SUNDRY NOTICES AND REPORTS ON WELLS

Mobil Apache #17

Re: Permanent Abandonment
Well: Mobil Apache #17

CONDITIONS OF APPROVAL

Proposed P&A

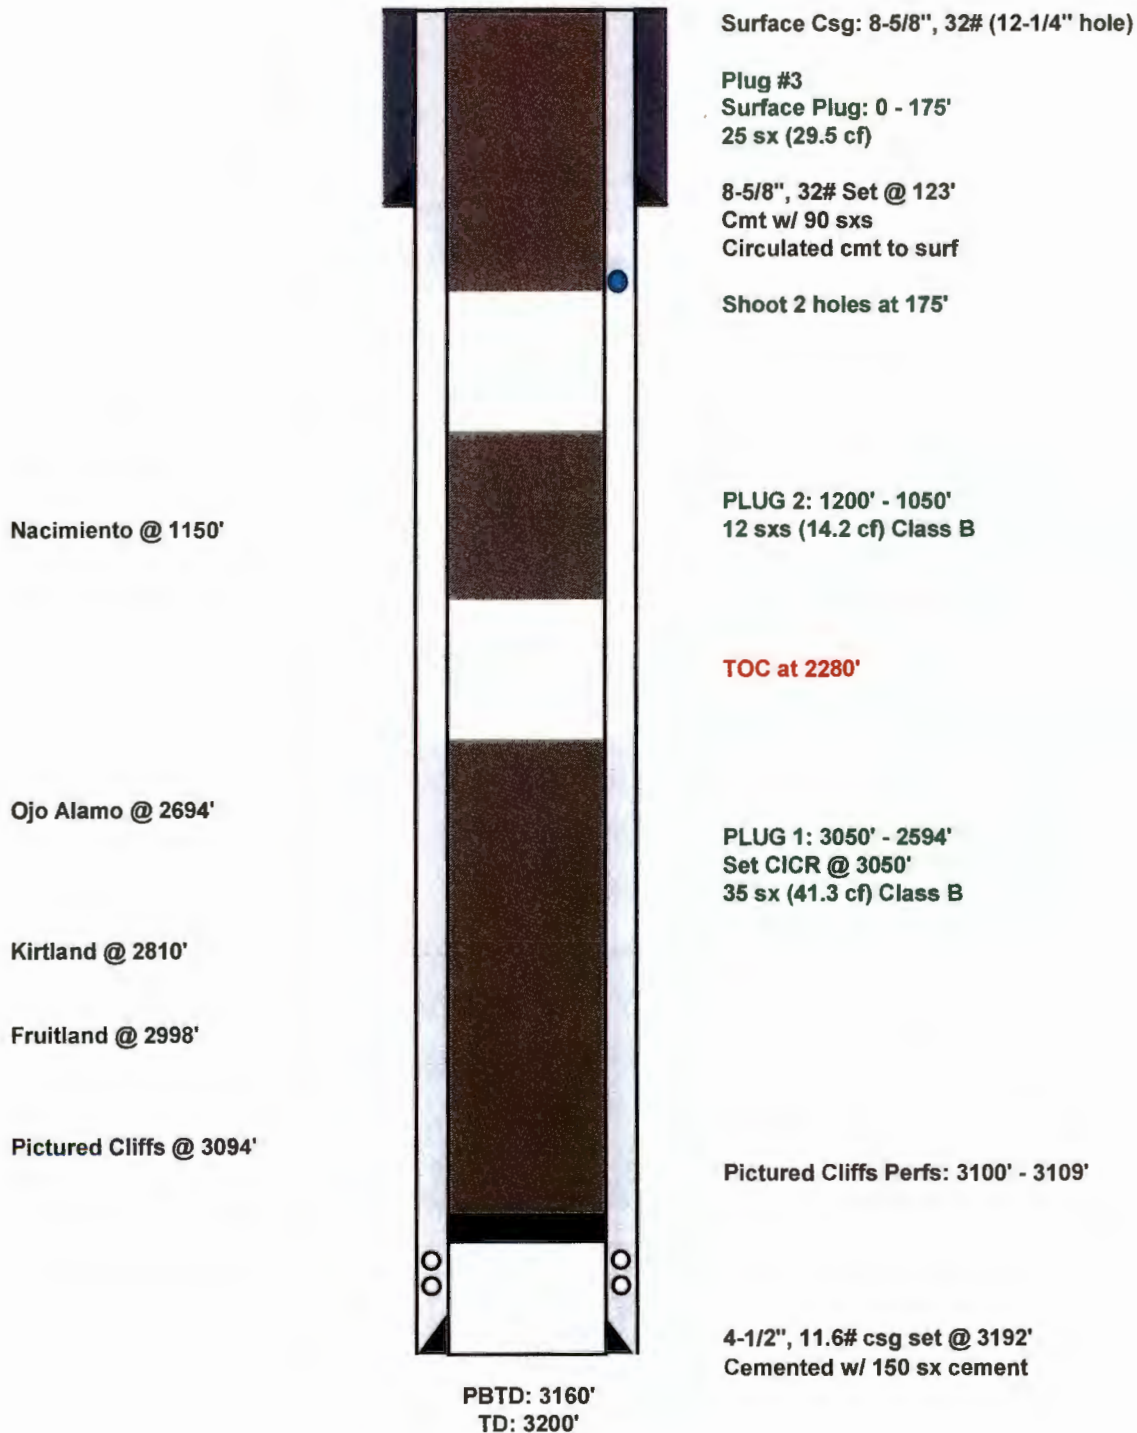
I: Set plug #2 (1435-1335 ft.) inside/outside to cover the top of the Nacimiento top. BLM picks top of Nacimiento @ 1386 ft. Outside plug will be required, TOC= 2280 ft. Adjust cement volume accordingly.
